USB PD CTS ENGINEERING CHANGE NOTIFICATION FORM

Title: TEST.PD.PS.SNK.1_ECR

Applied to: USB PD CTS Specification Version 1.0 Revision 1

Figure 4.17. Transition Diagram for Decreasing Voltage and/or Increasing Current

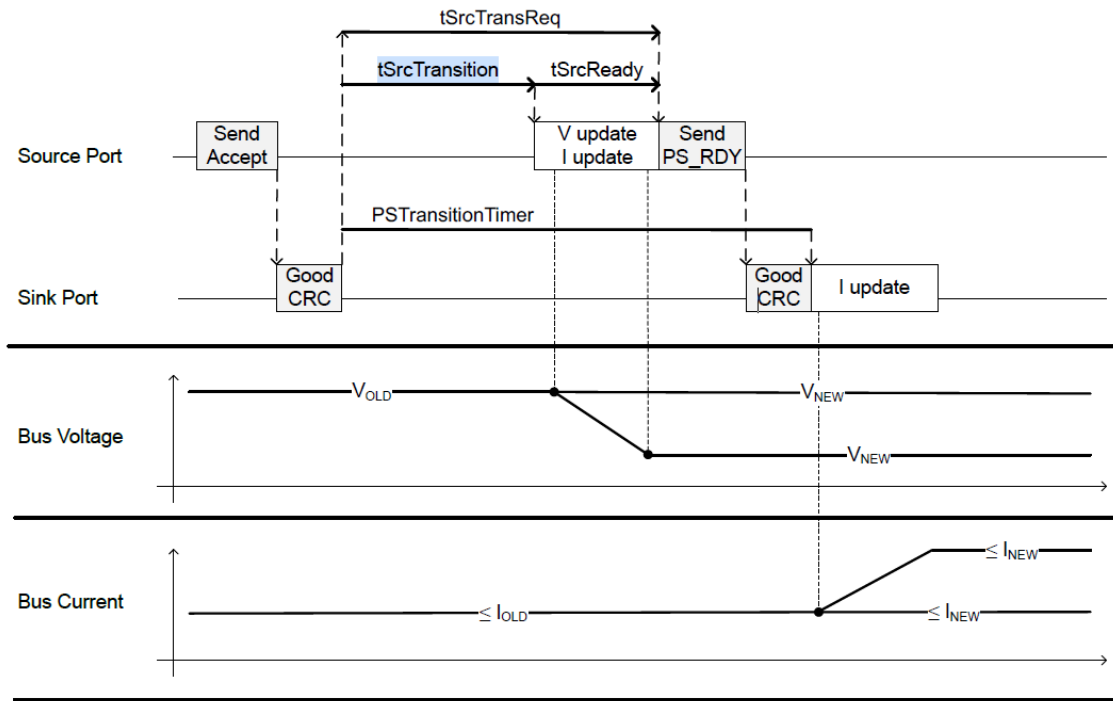
When Tester checks if the UUT responds correctly to a new Source Capability Message with the lowest PDO, 5V@0Amp), the Tester also checks if the UUT settles at the suspend current. The timer being used by the Tester is $t_{SrcTransition}$.

However, per the PD spec the power shall not change within this timeframe when Voltage is decreasing and/or current is either decreasing or increasing (on one diagram the current is increasing, on the other the current is decreasing.)

17. The Tester sends an *Accept* Message.
 - i. After a total of *tSrcTranReq* max, check that current drawn by the UUT does not exceed *pSnkSusp* max. [TEST.PD.PS.SNK.1#10]
